### REPORT SUMMARY MINOR VARIANCE APPLICATION FILE NUMBER A013/25

### MINOR VARIANCE APPLICATION FILE NUMBER A013/25

CITY WARD #:	4
APPLICANT:	Benjamin & Orit Smith
AGENT:	Contempo Studio
PROPERTY:	104 Sir Modesto Court, Maple
ZONING DESIGNATION:	See below.
VAUGHAN OFFICIAL PLAN	Vaughan Official Plan 2010 ('VOP 2010'): "Low Rise Residential"
(2010) DESIGNATION:	
RELATED DEVELOPMENT APPLICATIONS:	N/A
PURPOSE OF APPLICATION:	Relief from the Zoning By-law is being requested to permit the construction of a proposed two-storey dwelling, retaining wall, swimming pool, accessory structure (pool mechanical) and uncovered platform.

$1 \frac{\text{RETAINING WALL SECTION 1}}{3/8" = 1'-0"}$

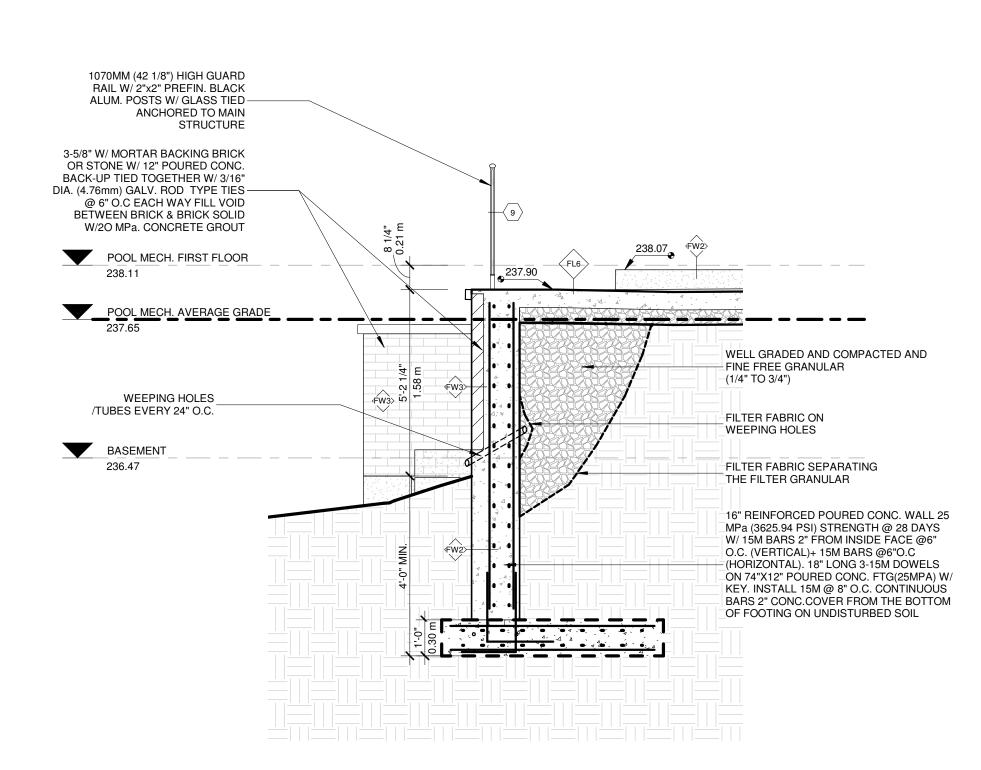
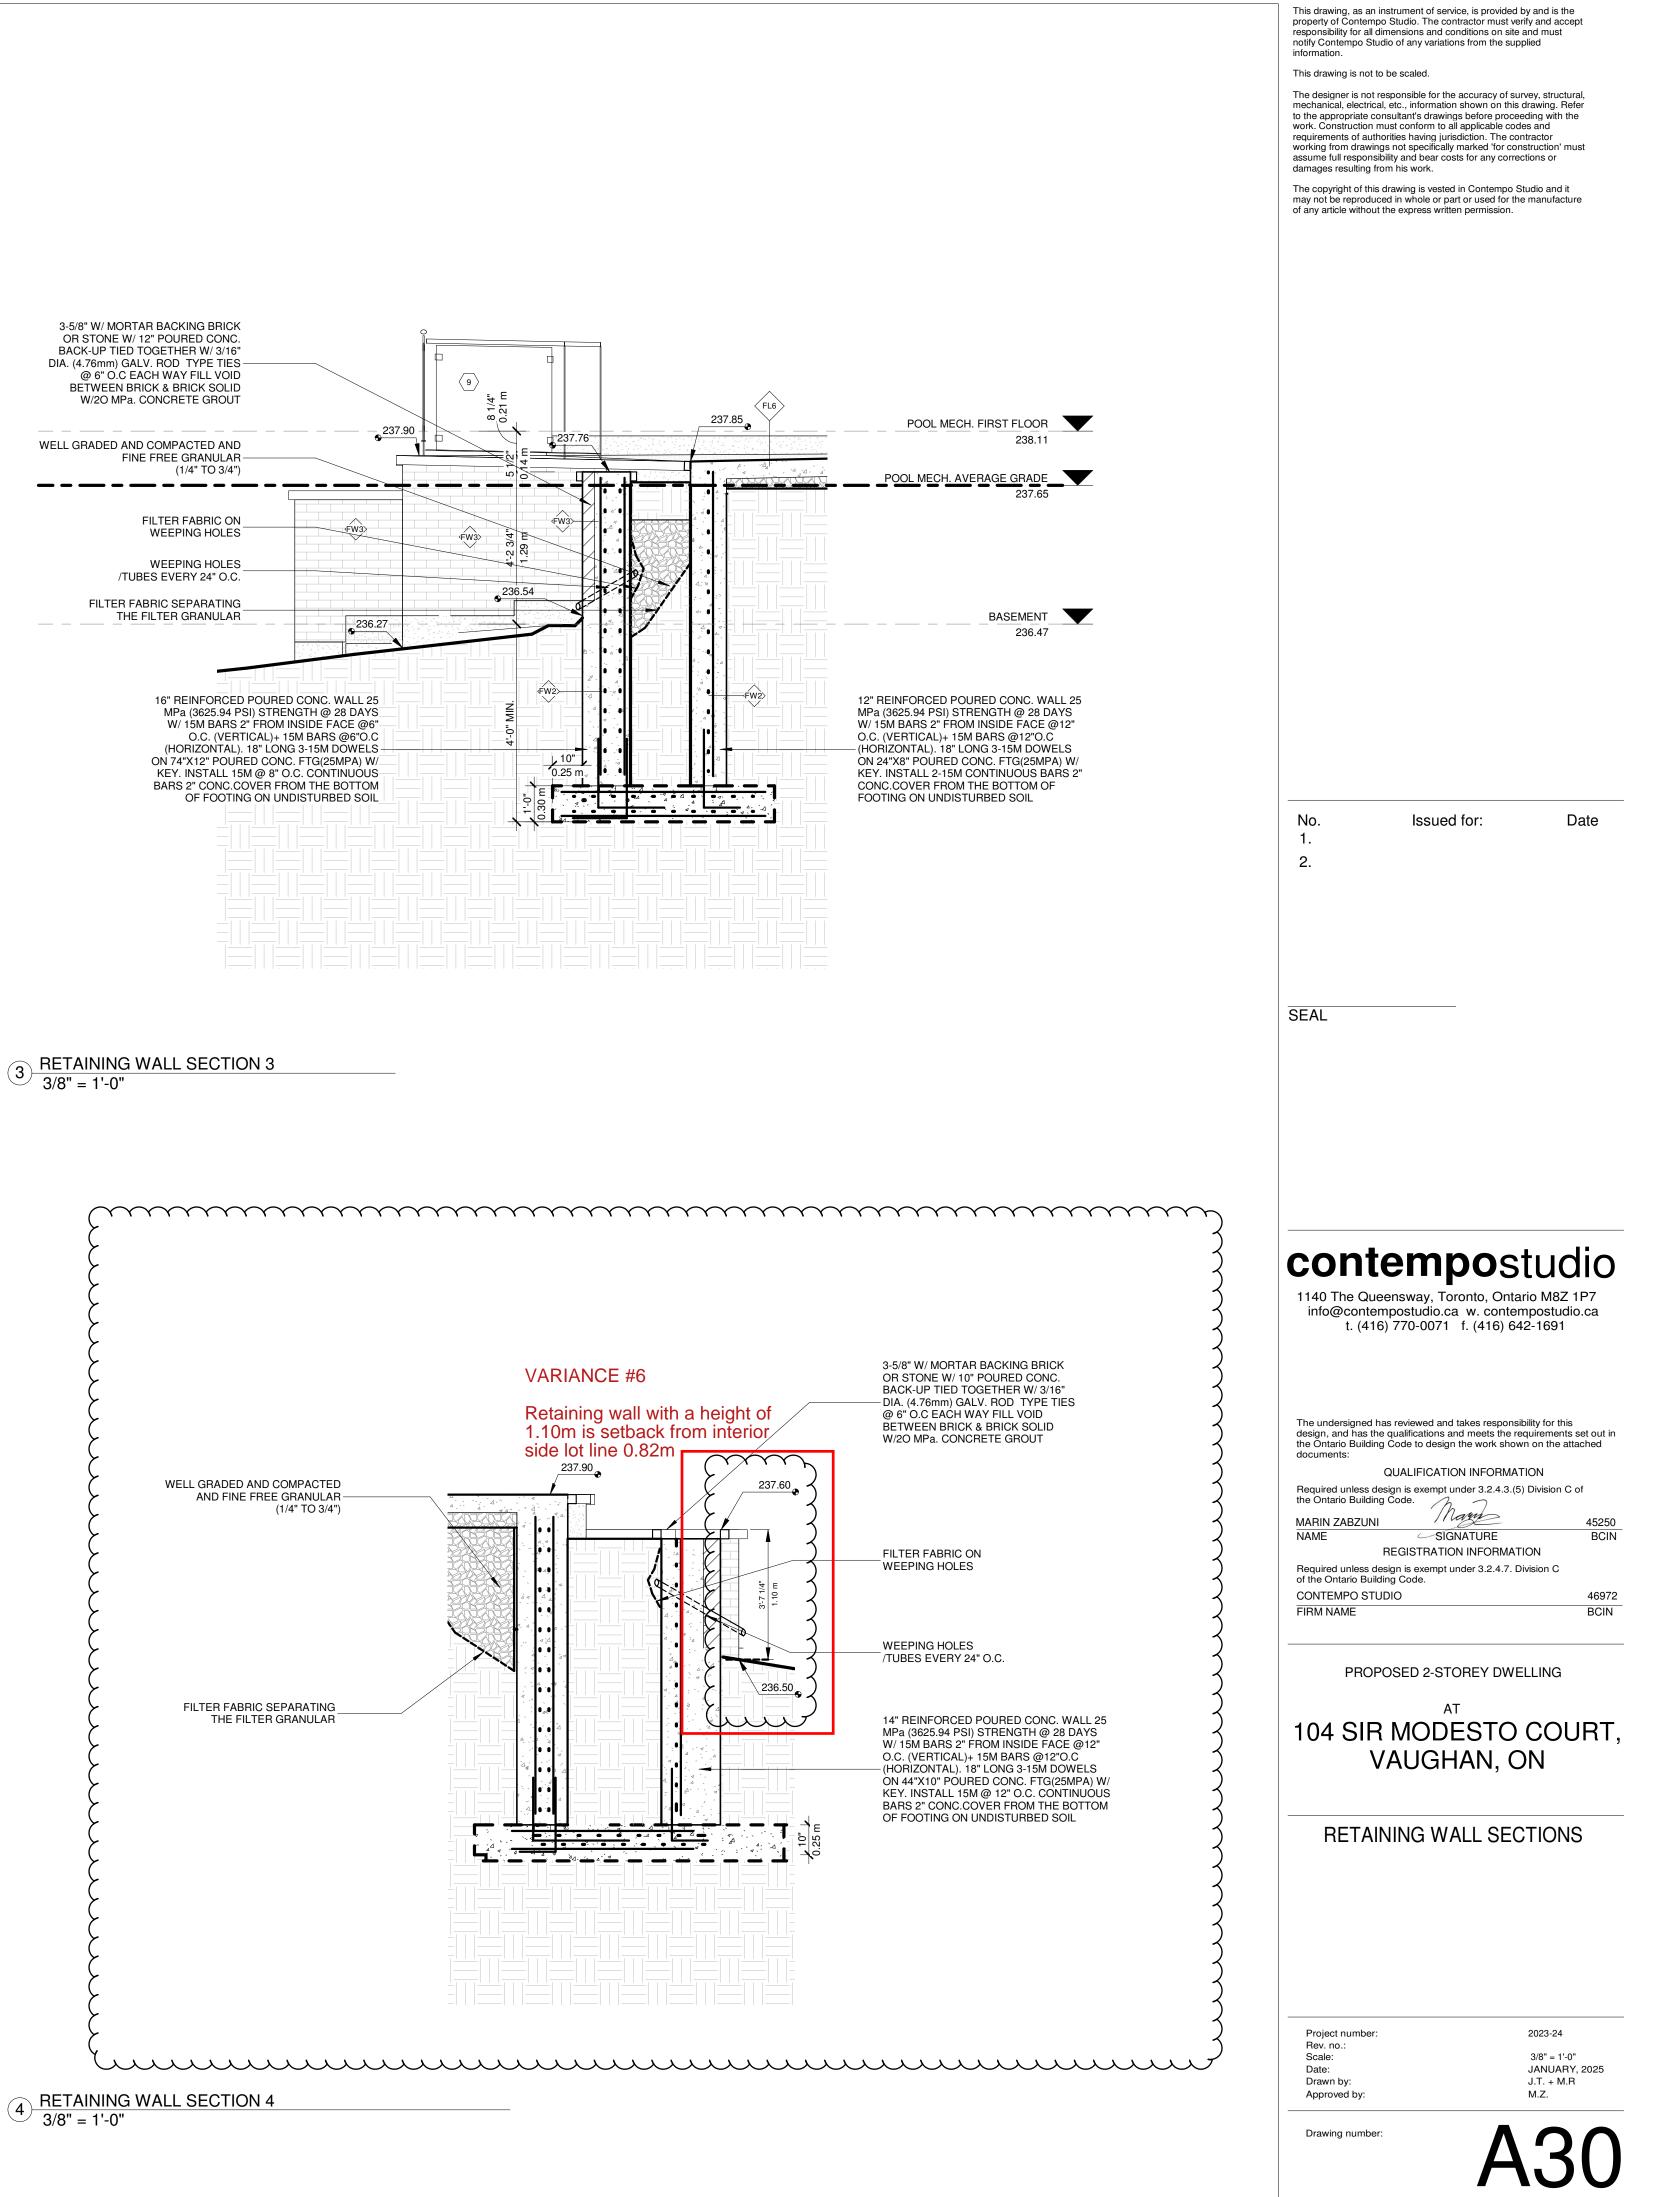
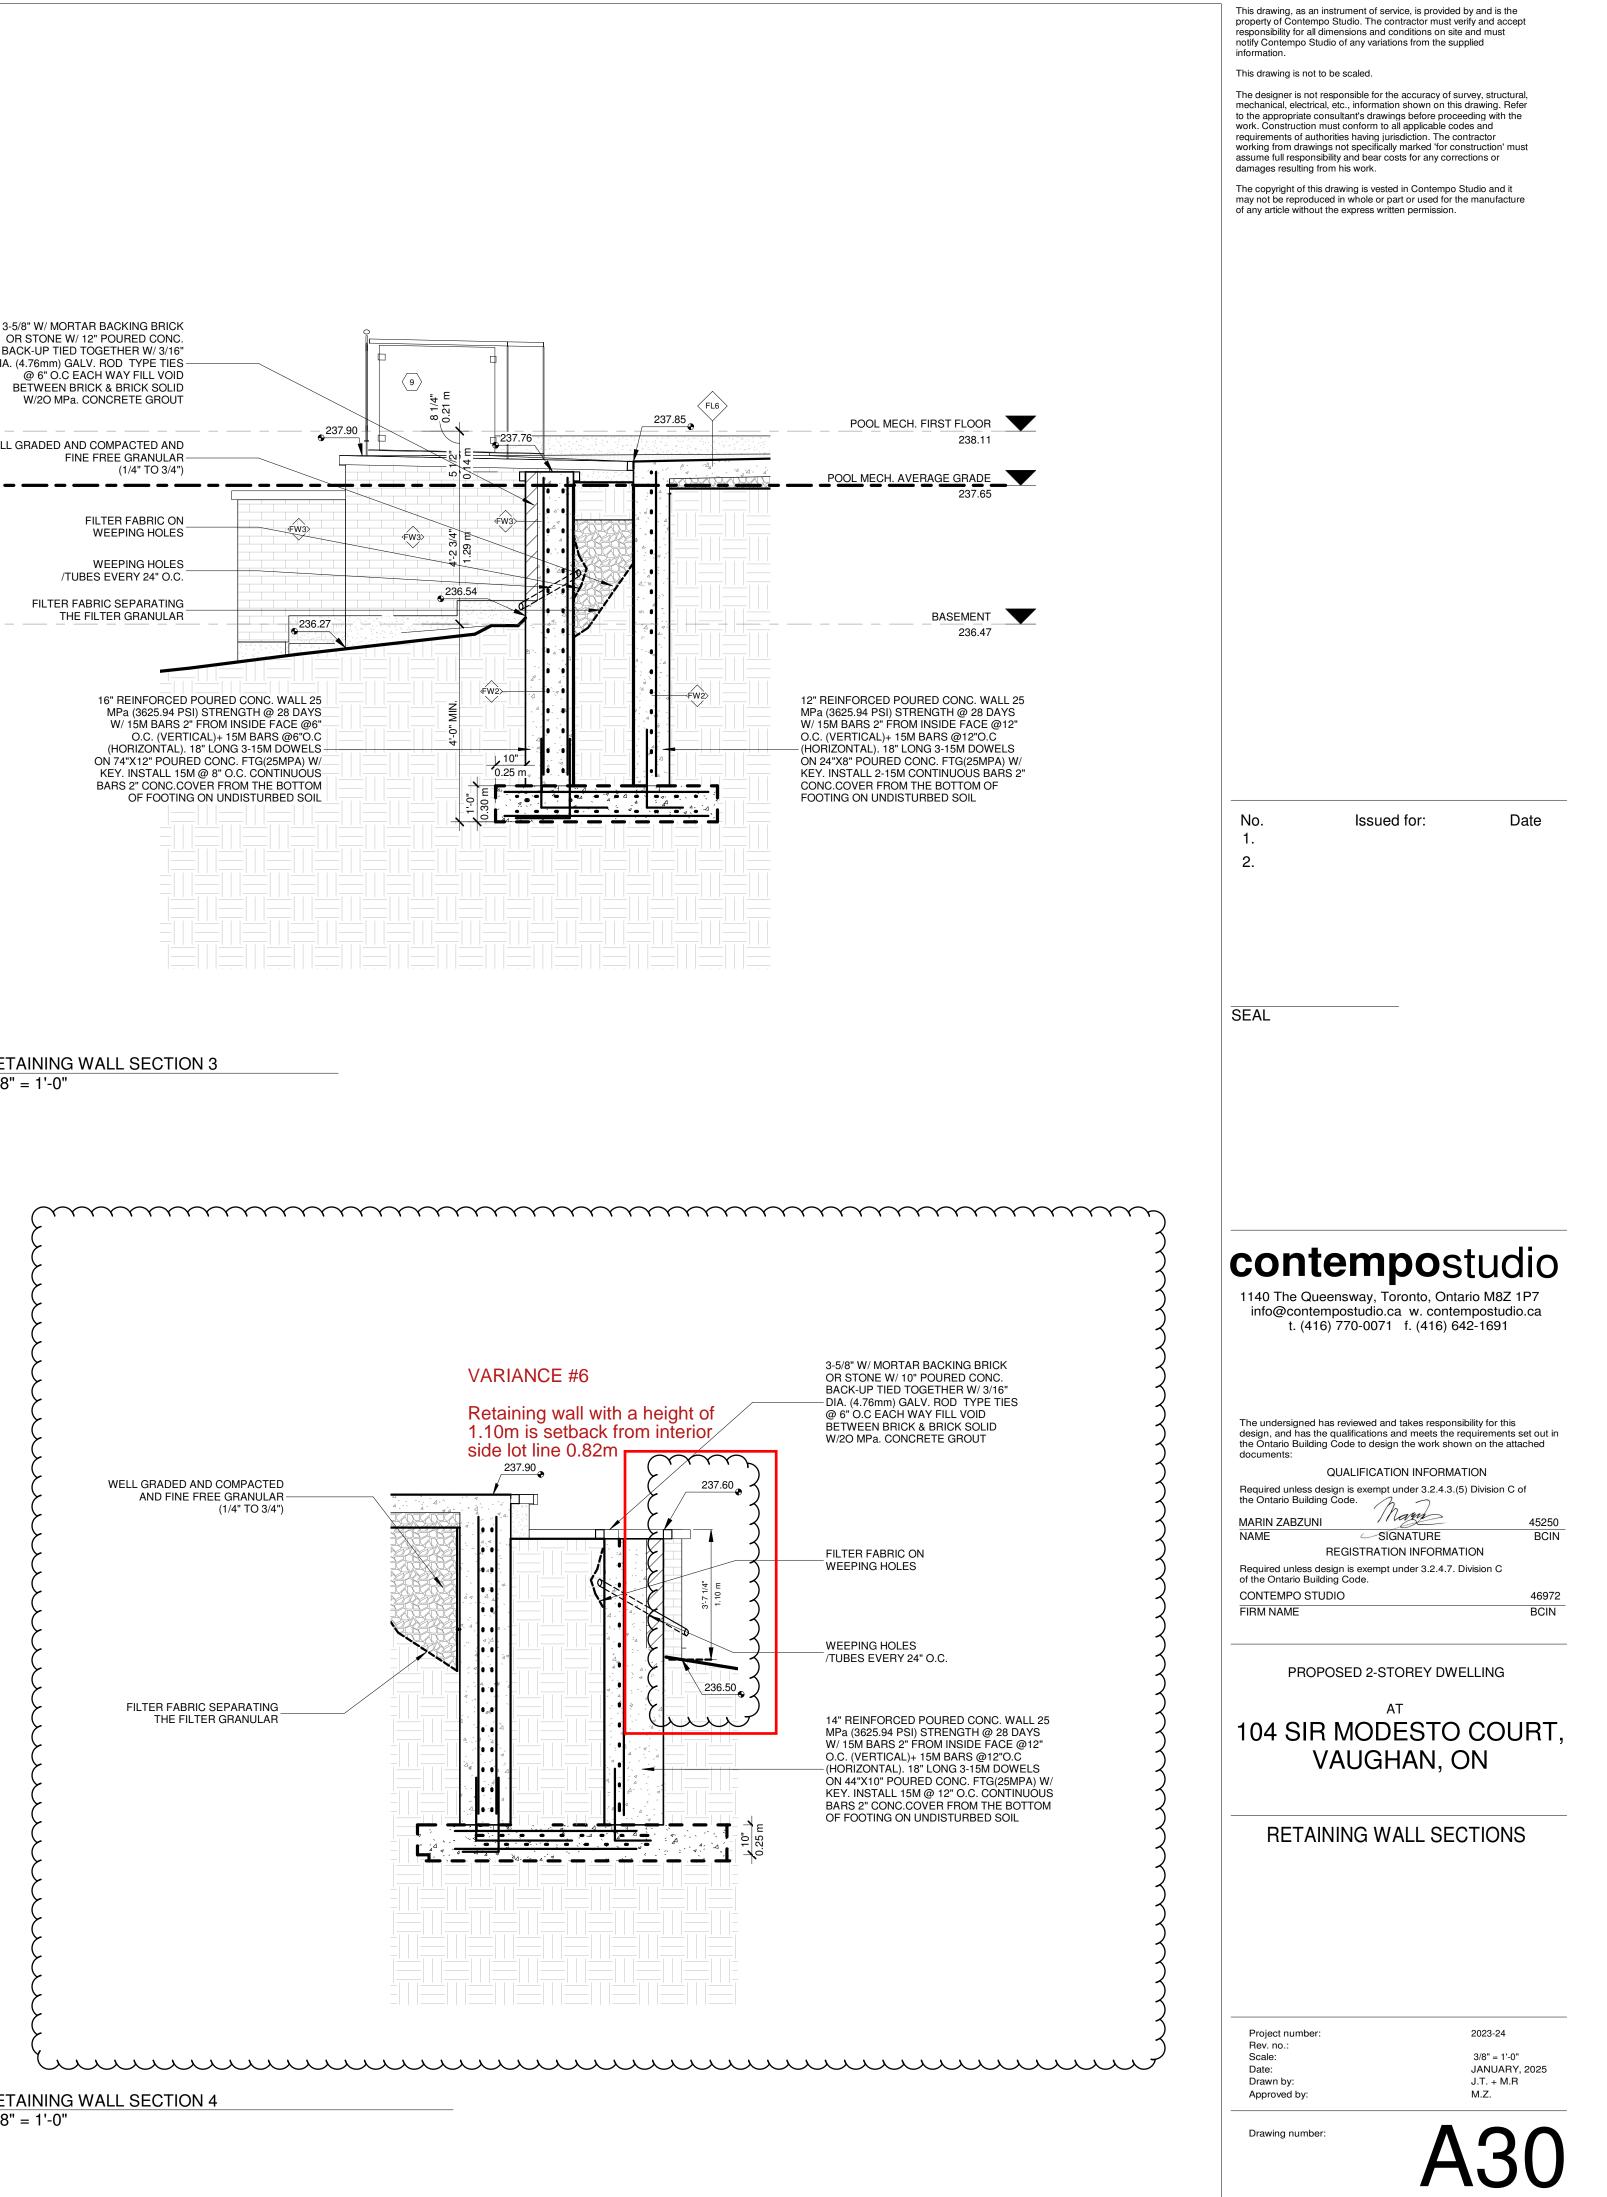
Development Engineering staff have reviewed the proposed dwelling and rear yard and do not object to the raised terrace and associated retaining walls. Environmental Planning staff and TRCA staff have reviewed the application and are satisfied that the proposed structures and raised terrace are adequately setback from a nearby Provincially Significant Wetland and other core environmental features.
